Further Information Response Report

Grinding Proposal at Portersize
& Timolin, Ballitore, Co. Kildare
– PI Ref. 20/1329

Project Title: **Infilling Proposal at Portersize & Timolin, Ballitore, Co. Kildare – PI Ref. 20/1329**

Document Title: **Further Information Response Report**

Figure 4 - Existing and Proposed Site Drainage

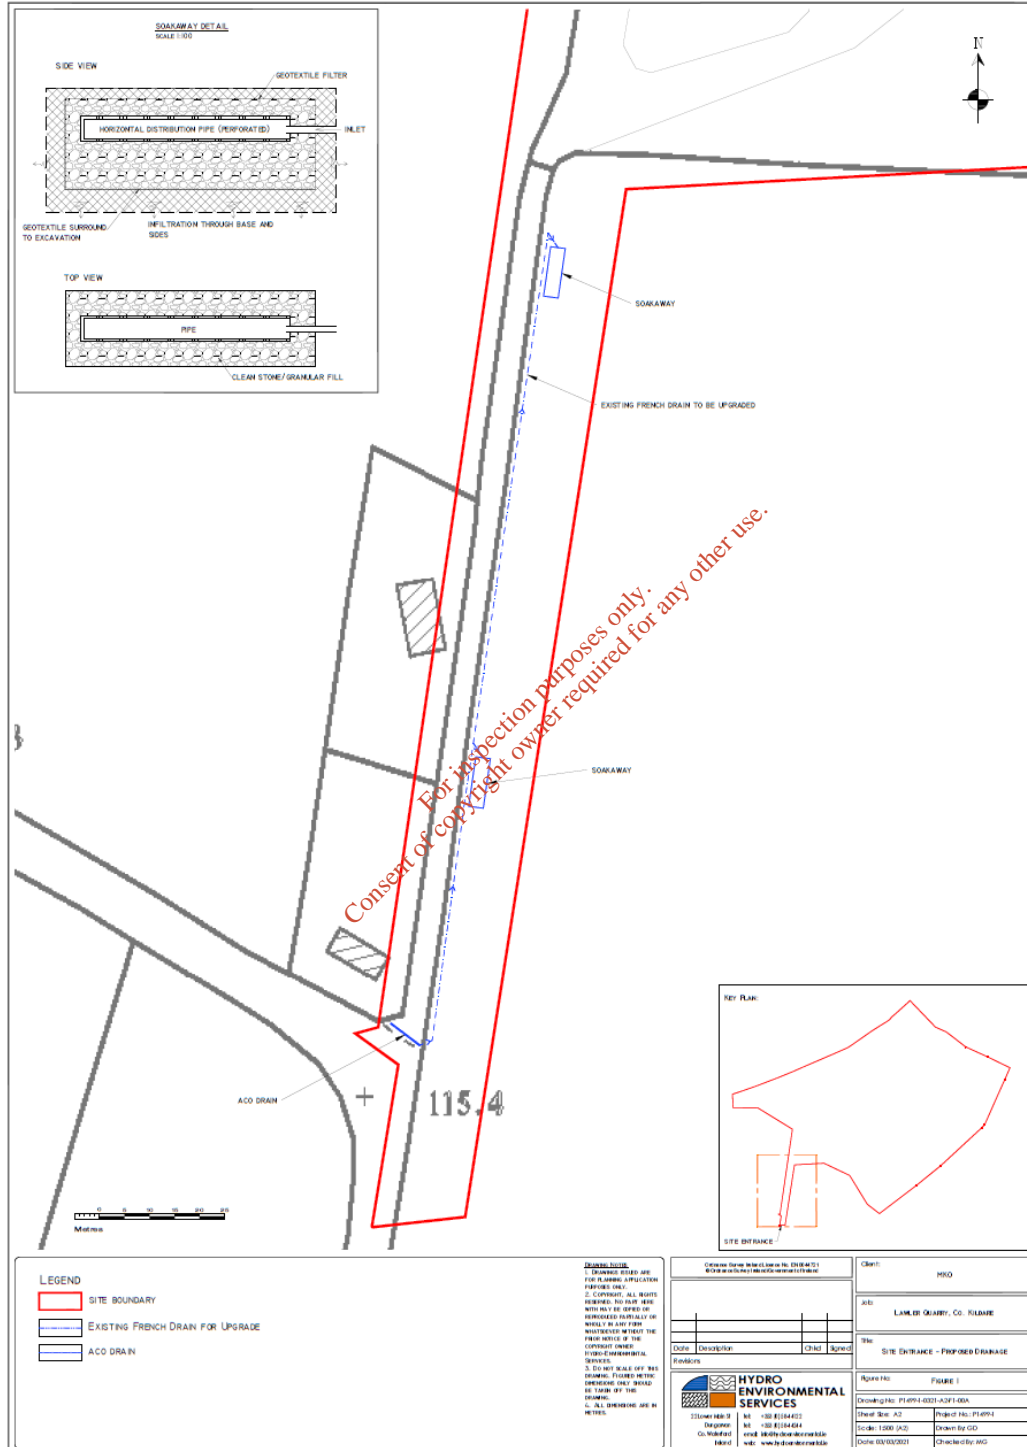
2.17 **Item No.9 – Water Drainage**

The Applicant is requested to provide details of the surface water drainage at the entrances.

We refer the Authority to the enclosed Further Information Note prepared by Hydro-Environmental Services. Please also see Figure 4 above which shows details of the existing and proposed drainage for the site entrance road leading out to the R747. The full drawing is also enclosed with this submission, prepared at an appropriate scale.

There is an existing French drain which runs along the eastern side (upslope side) of the site entrance road (refer to Figure 4). The drain runs from the site entrance on the R747 as far as the internal entrance leading into the sand and gravel pit itself.

Proposed drainage upgrade works for the site entrance and site entrance road are as follows:

- Excavate/removal of the existing 40mm drainage stone within the French drain and replace with clean 40mm stone;
- Install 2 no. soakaways along the drain to facilitate percolation of drainage water; and,
- Installation of an ACO drain at the site entrance on the R747 which will feed into the entrance road French drain.

Figure 5 - Locations of Tanks, Wells, Streams & Ditches

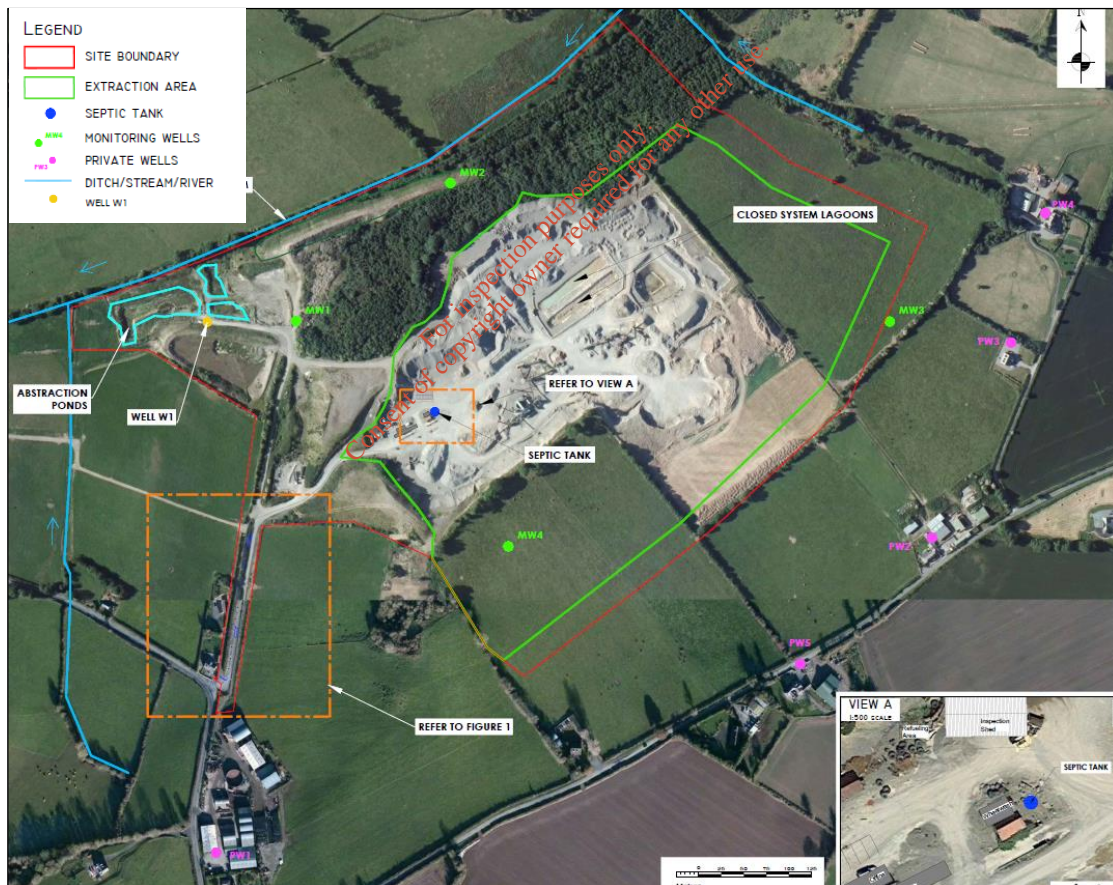
2.21 Item No.11 – Tanks/Treatment Systems Location Plan

The Applicant is requested to indicate on a Site Layout Plan (1:500 scale) the exact location of any septic tanks/wastewater treatment systems and wells on or adjoining the site and the extent of all streams/ditches that are on, bordering, or adjacent to the site.

Please see Figure 5 below for Site Layout drawing (also refer to Figure 2 in enclosed Hydro Environmental Services Response Note) at scale 1:2,500 showing the location of the septic tank, on-site wells, private wells adjoining the site and the extent of all streams/ditches that are on, bordering, or adjacent to the site.

It was agreed with Kildare County Council that a 1:2,500 scale drawing would be more appropriate than a series of 1:500 scale drawings for the entire site as originally requested in the RFI. The critical areas of the site entrance (Figure 1) and septic tank area (View A on Figure 2) are provided at 1:500 scale.
